ADDENDUM NO. 1

PROJECT NAME: NE Soccer & Tennis Complex- General Construction
UNL PROJECT NUMBER: C909P101/ 10186
BID INVITATION NUMBER: 2339-14-7200

CONSULTANT: RDG Planning & Design
ADDRESS: 301 Grand Avenue
Des Moines, IA 50309

DATE OF ISSUANCE: March 27, 2014
DATE OF BID OPENING: Tuesday, April 8, 2014
3:00 PM CT

Project Number: 2013.512.00	Date: 03/27/14	Add to Sheet:	Drawing: A1.61	AD1-A08
-----------------------------	----------------	---------------	----------------	---------

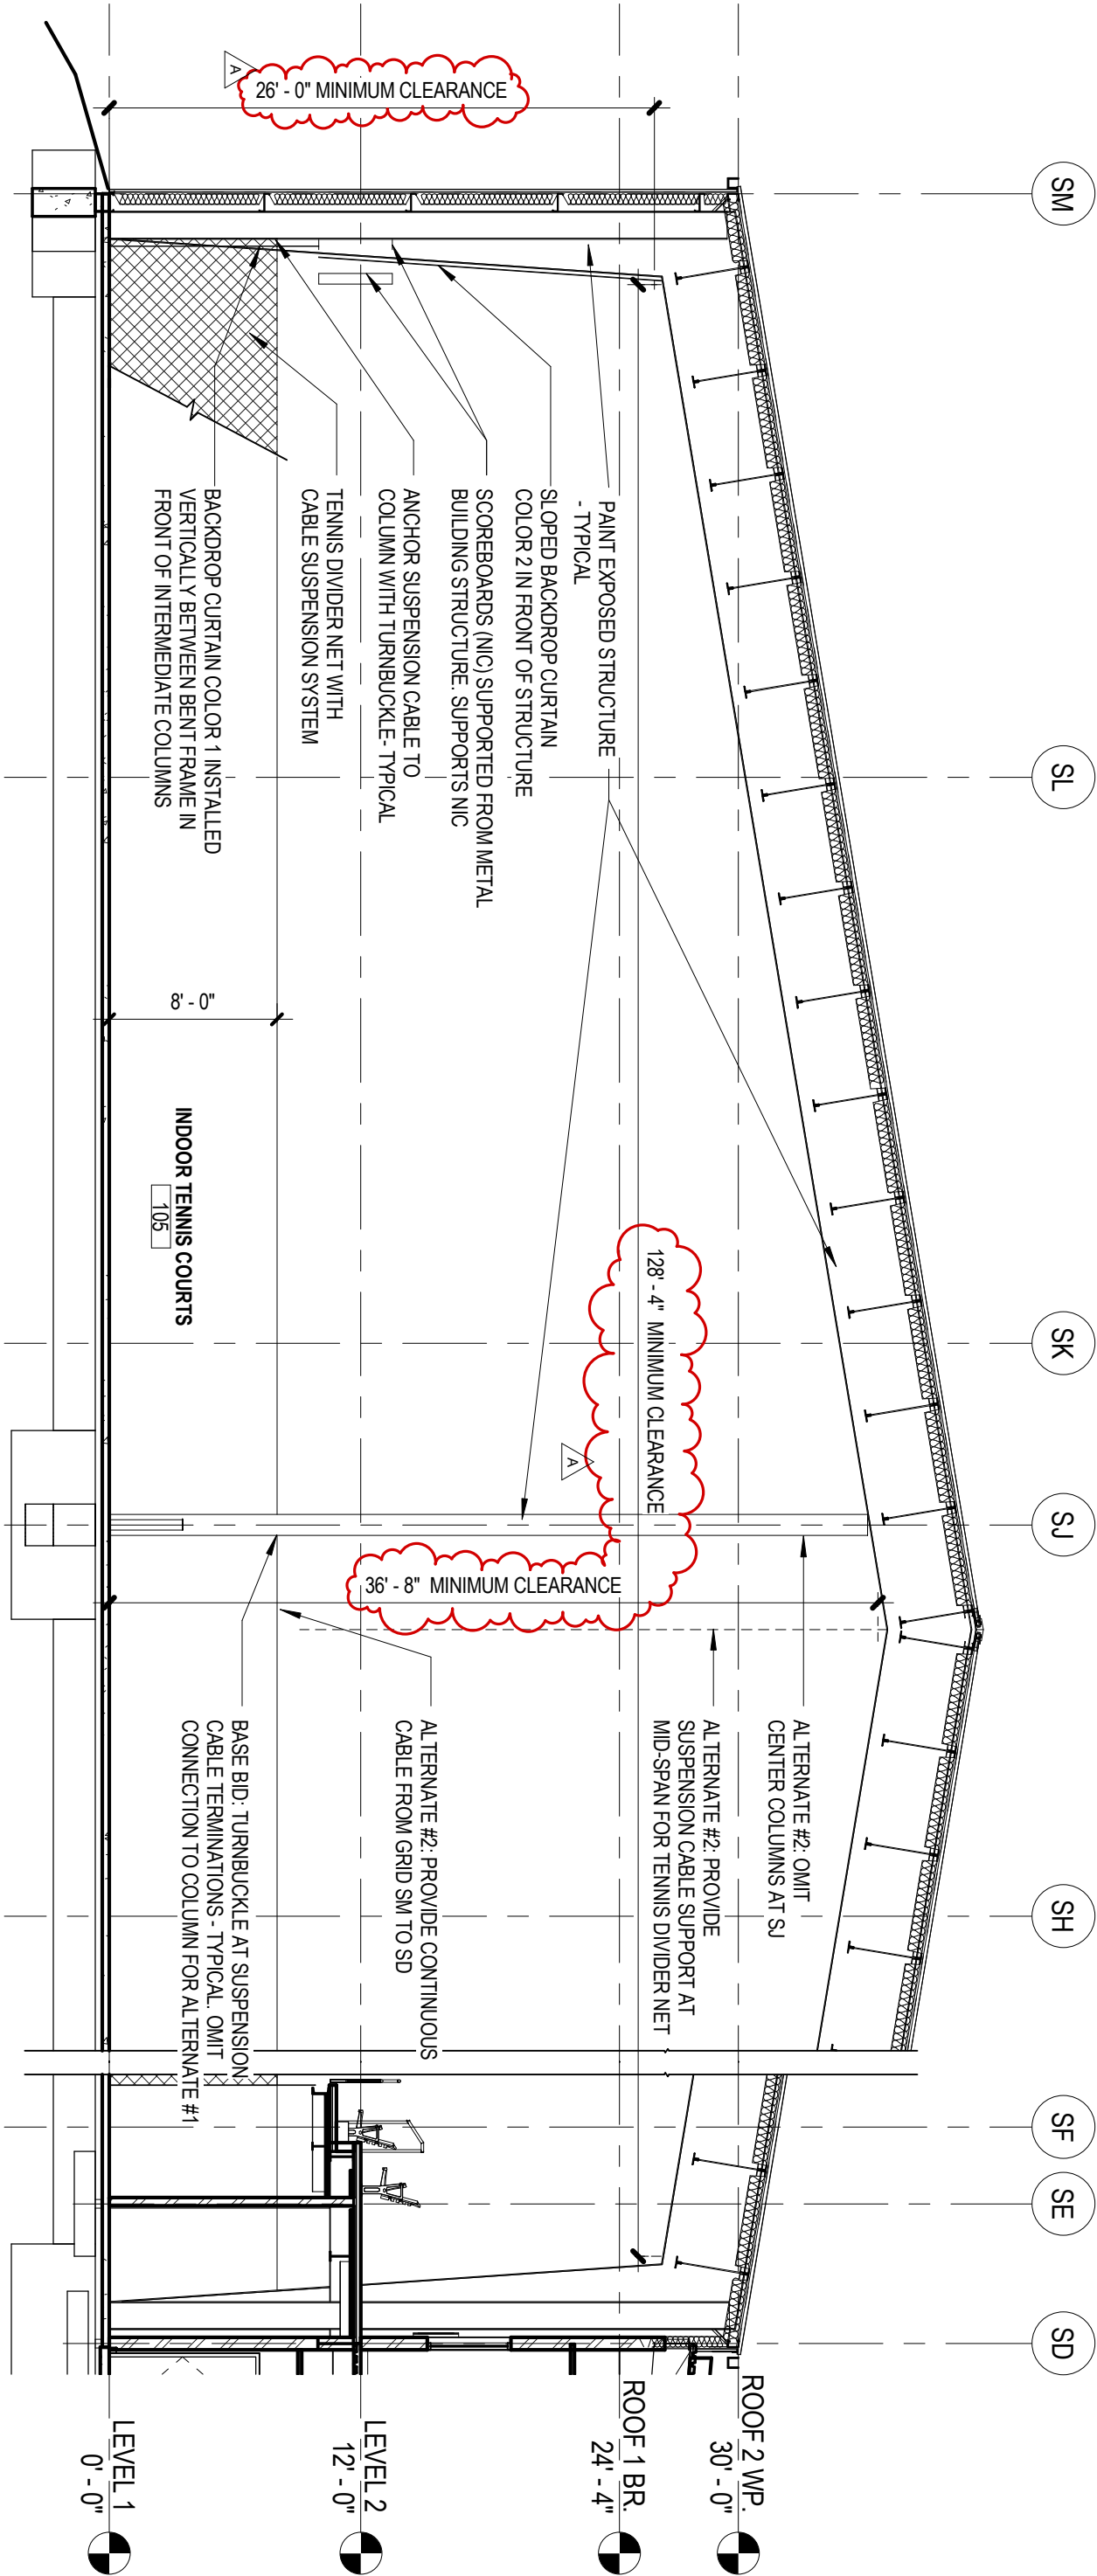
- A. Add minimum clearance dimensions to the Metal Building main rigid frame. See attached drawing AD1-A08.

SERVICE GROUNDING
 NO SCALE

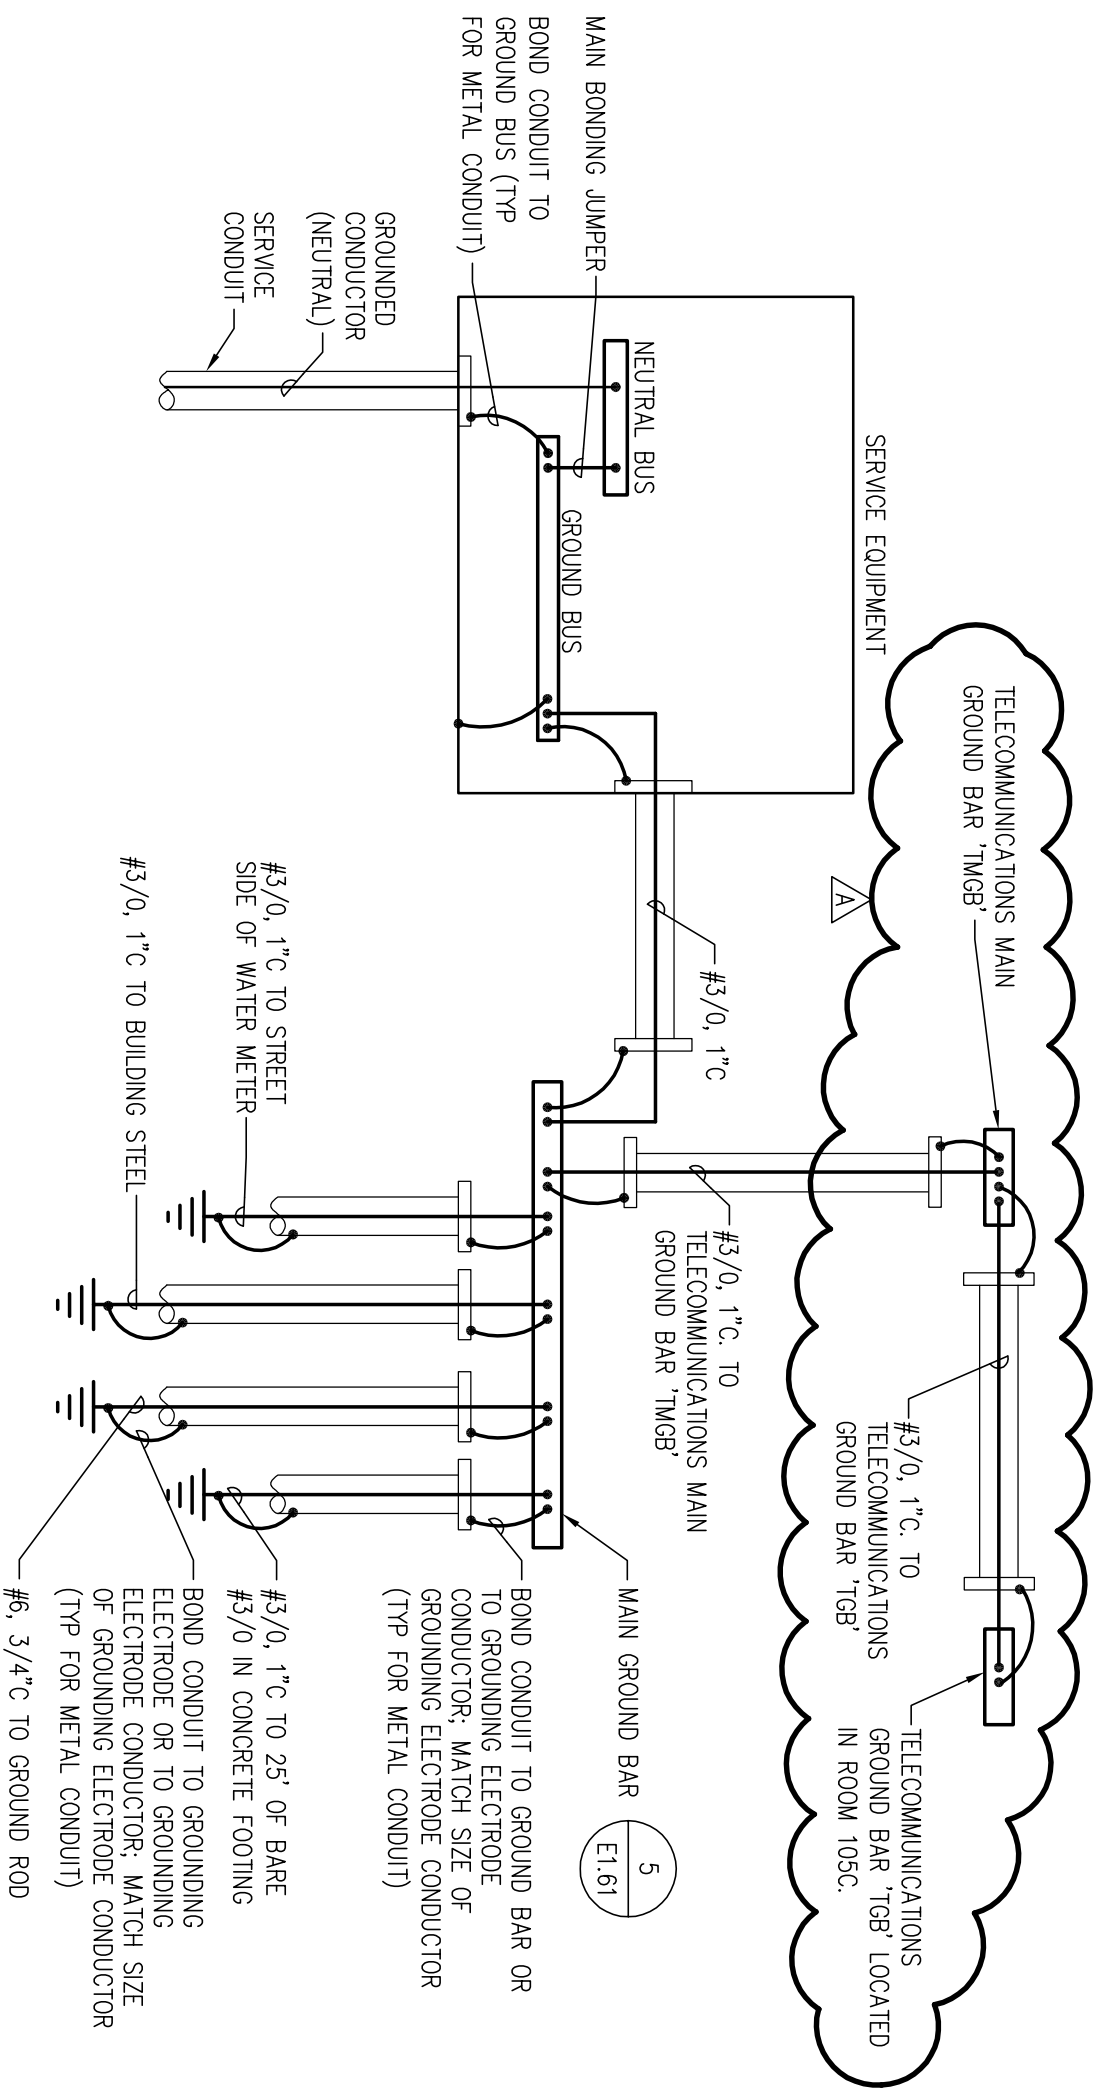
- A. Detail 6 – Service Grounding. Revise the detail per attached supplemental drawing AD1-E06.

RDG Planning & Design • Omaha, NE • Des Moines, IA	Project Number: 2013.512.00	Date: 03/27/14	Change to Sheet:	Drawing: AD1-T02
	UNIVERSITY OF NEBRASKA - LINCOLN			
	ADDENDUM 1		UNL SOCCER & TENNIS COMPLEX

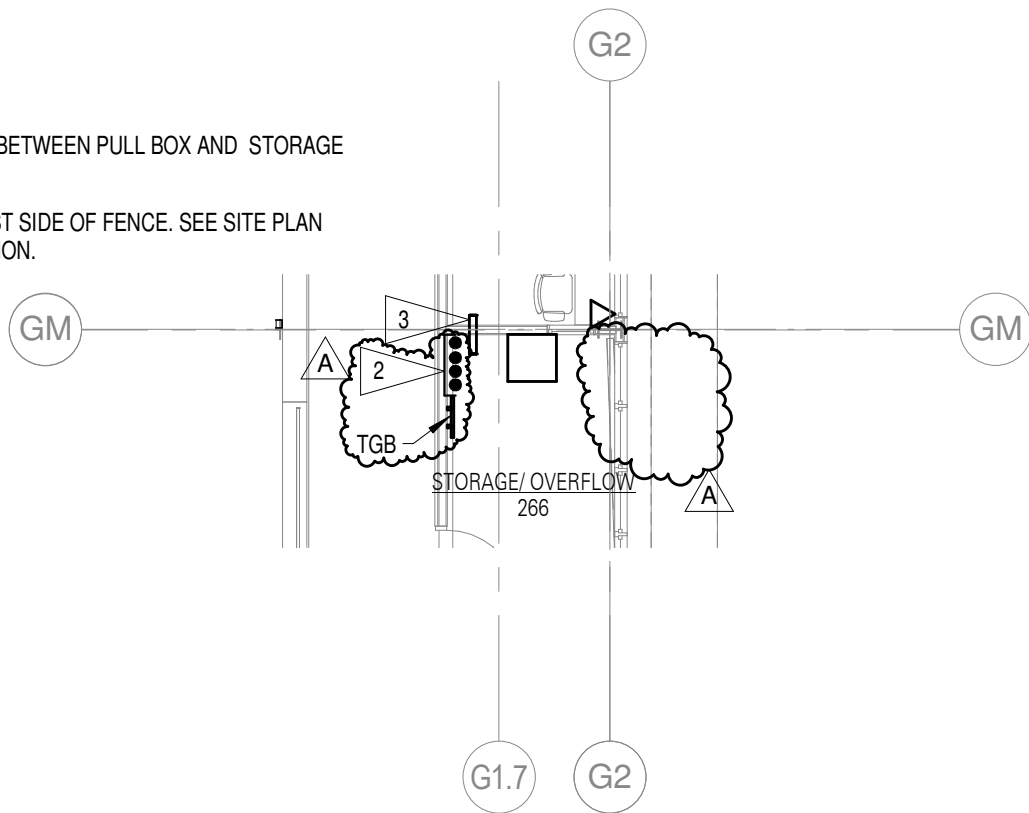
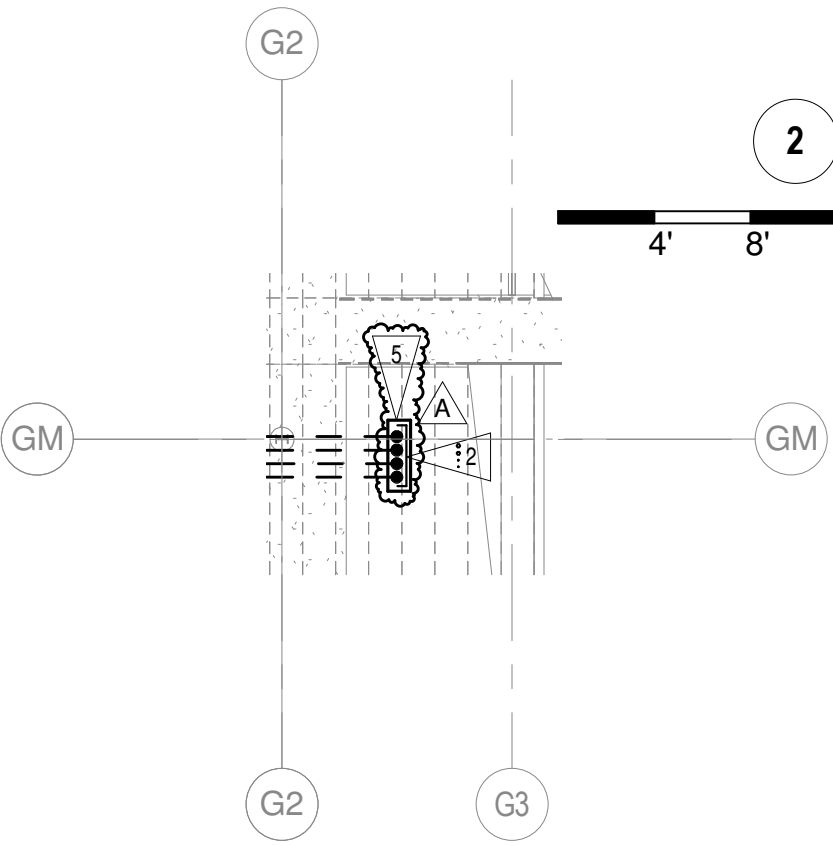
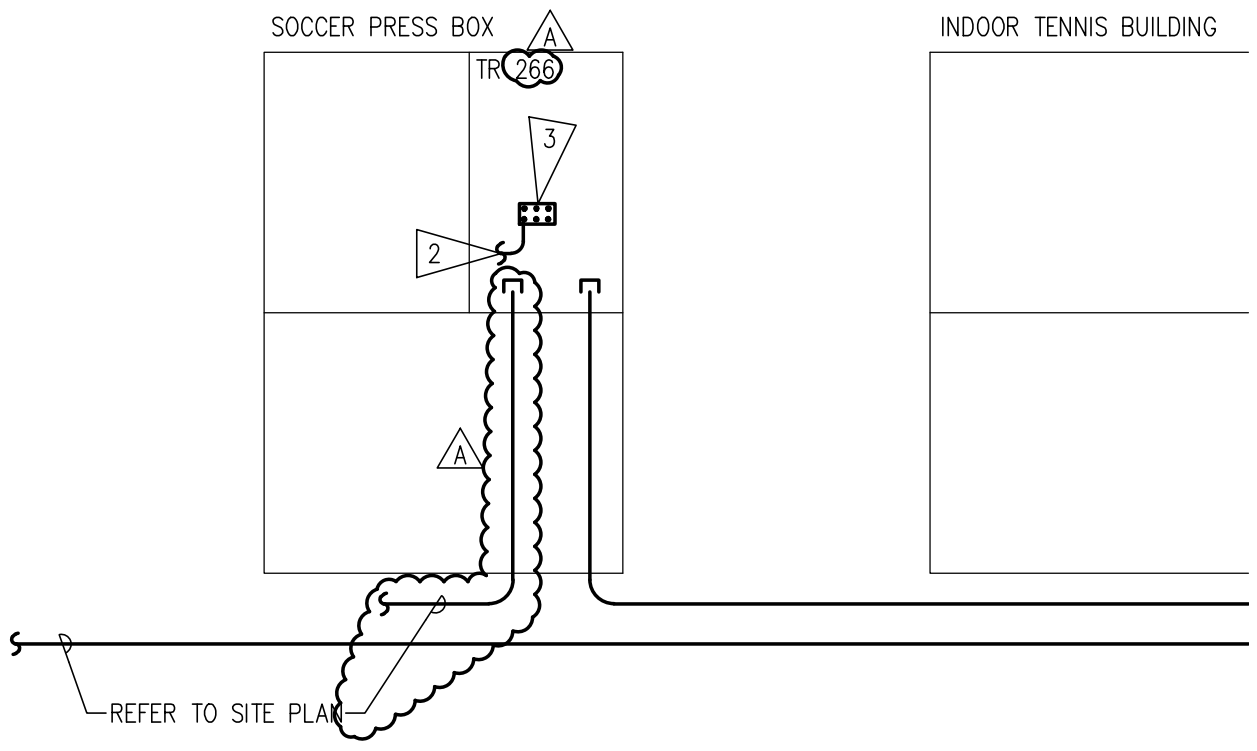
A. Clarify storage 266 conduit location and requirements per attached supplemental Drawings AD1-T02.

PATHWAY/GROUNDING SCHEMATIC

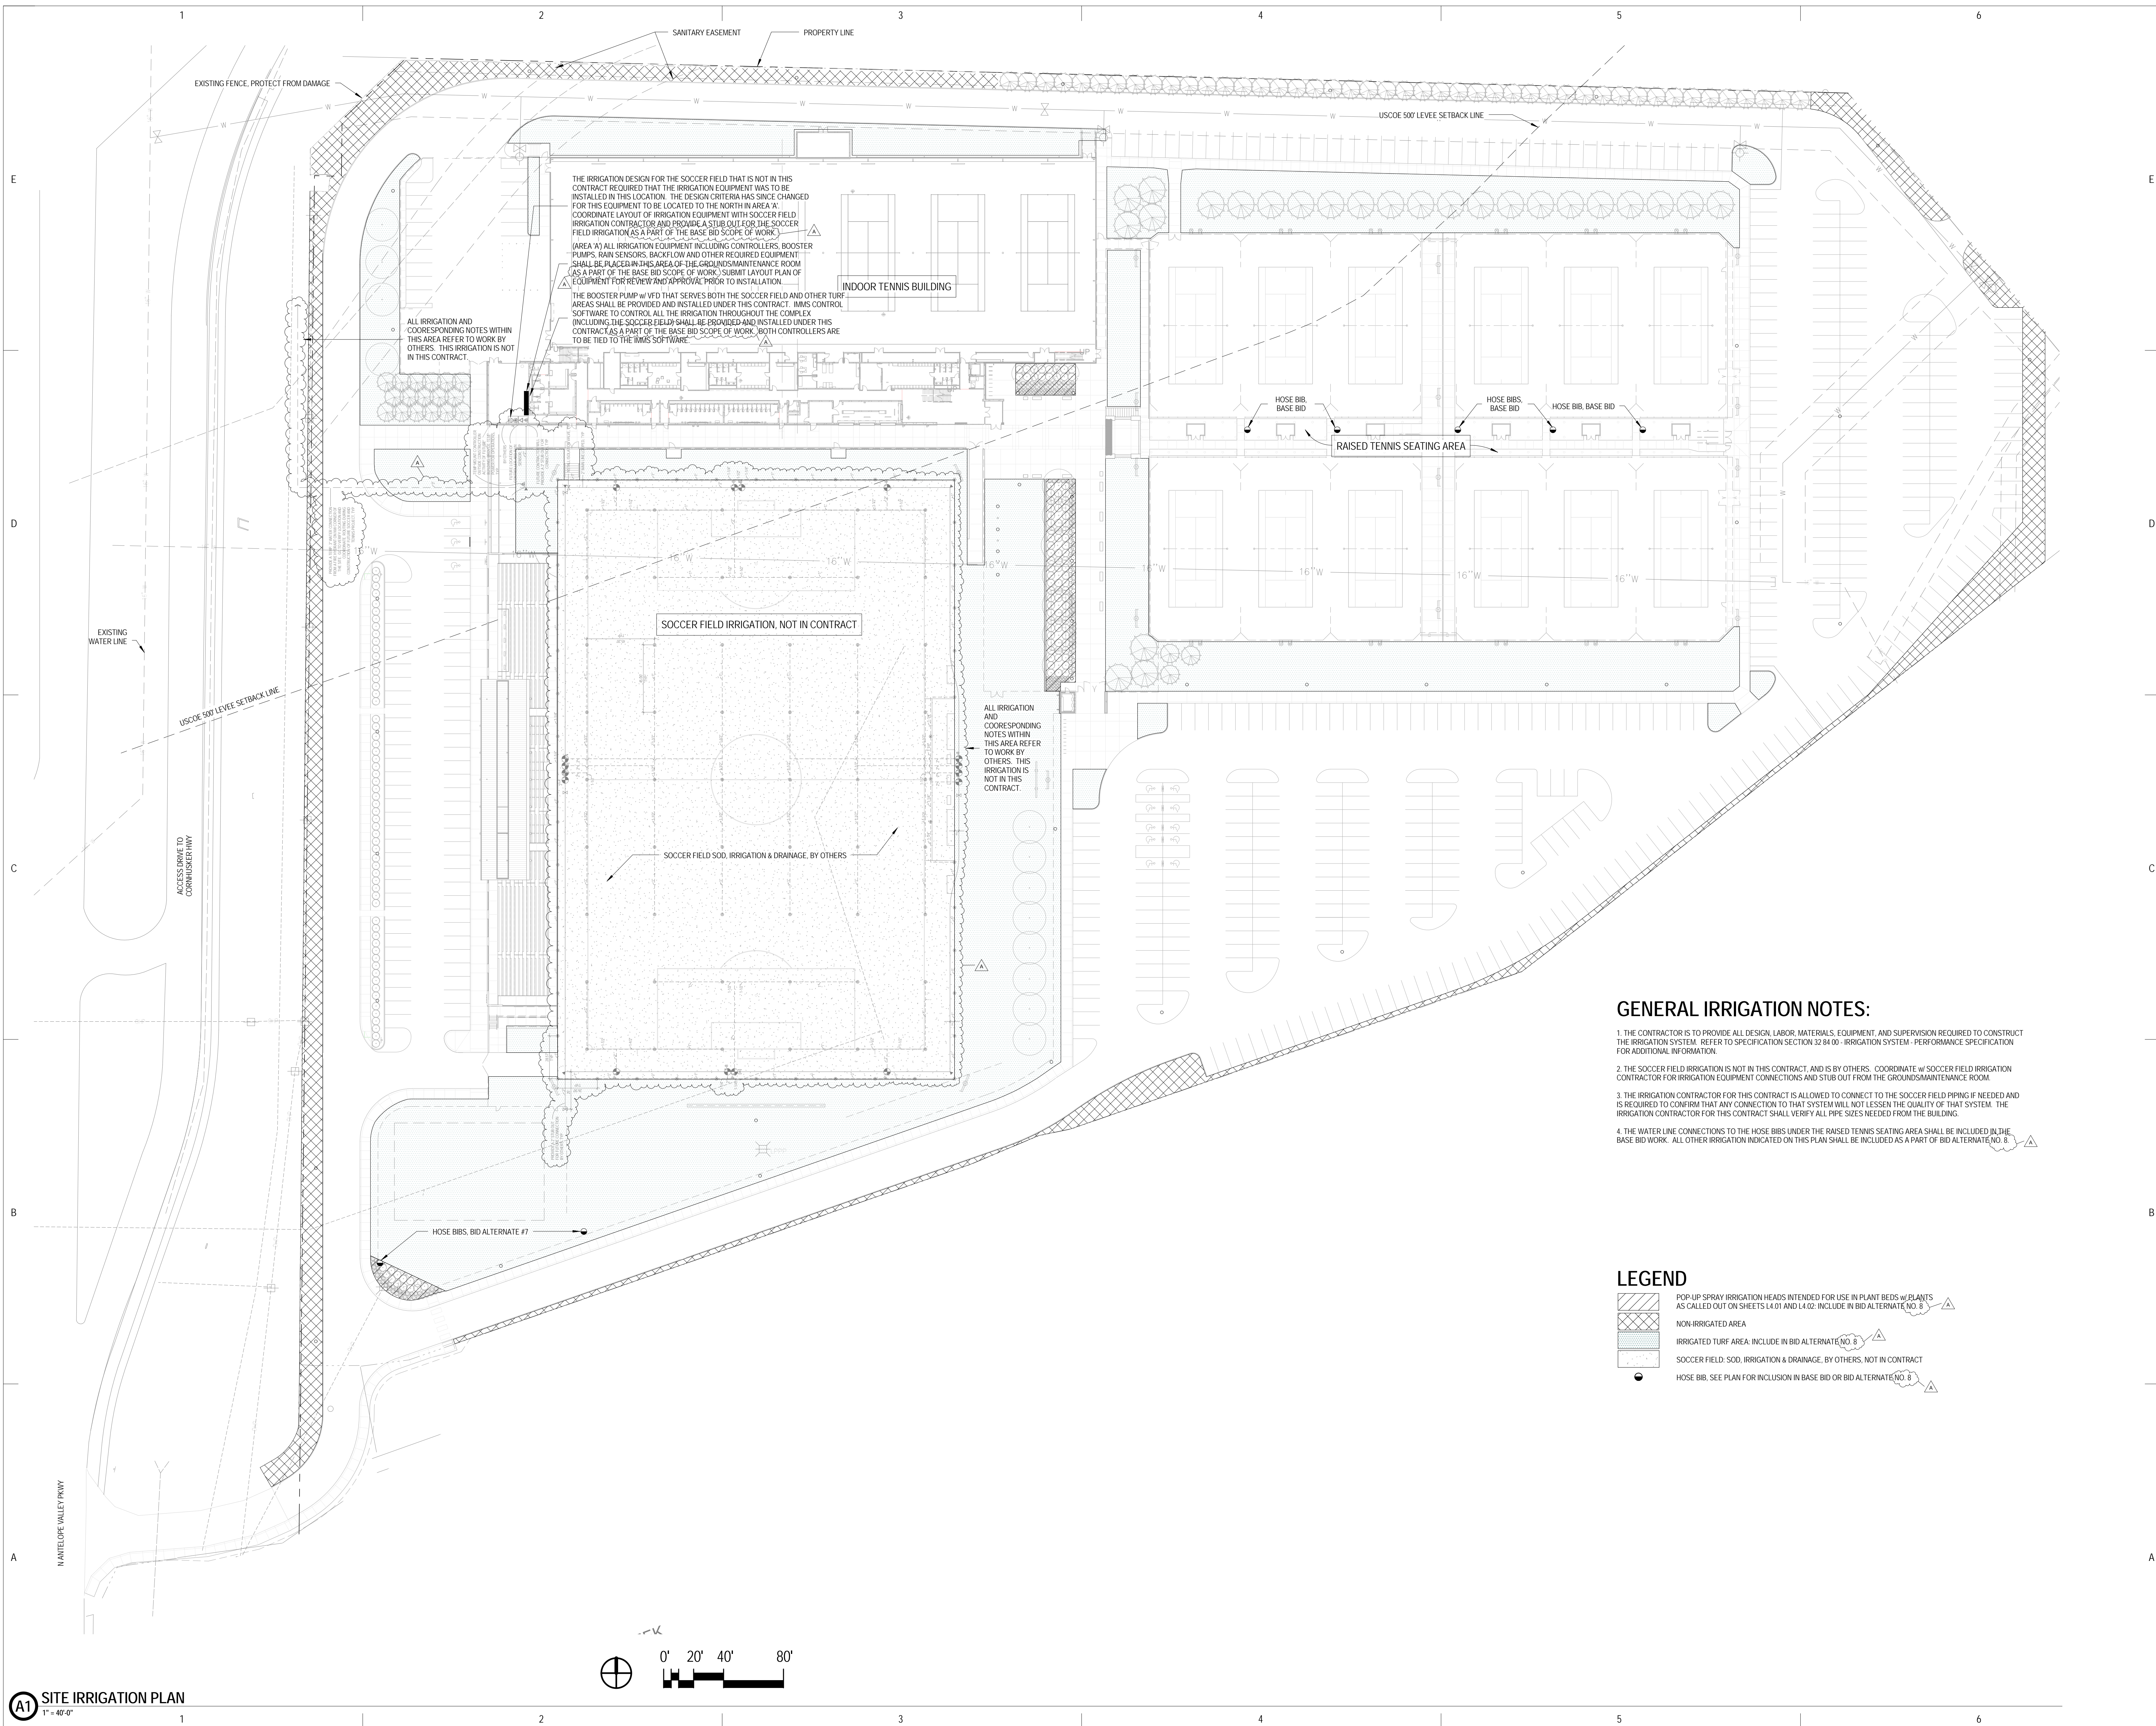
A. Clarify soccer press box pathway and TR room number per attached supplemental Drawing AD1-T03.
